Broad Band Noise Test Specification for Clause 202

Feb 03, 2026

Ahmad Chini, Broadcom

Figure 201-36—Broadband stationary noise rejection test setup, -T1

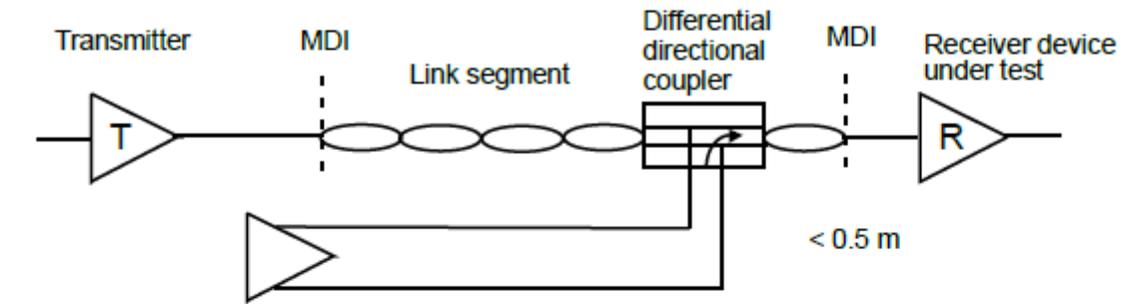
This specification is provided to verify for the receiver's tolerance to broadband stationary noise from a variety of sources. The test is performed with a noise source consisting of a signal generator with Gaussian distribution, bandwidths, and magnitudes shown in Table 202-??. **The minimum noise frequency is 10MHz.** The receive DUT is connected to the noise source through a directional coupler, as shown in Figure 202-??. with a link segment as defined in 202.? for -T1 and shown in Figure 202-??. with a link segment as defined in 202.?? for -V1. The BER is expected to be less than 10^{-12} , and to satisfy this specification, the frame loss ratio is less than 10^{-9} for 125-octet packets measured at the MAC/PLS service interface.

Editorial Note:

- 1-Set the figure and table numbers as fits into 202 clauses.
- 2-Editorial note to align this caluse with other changes that were made in this ballot cycle.
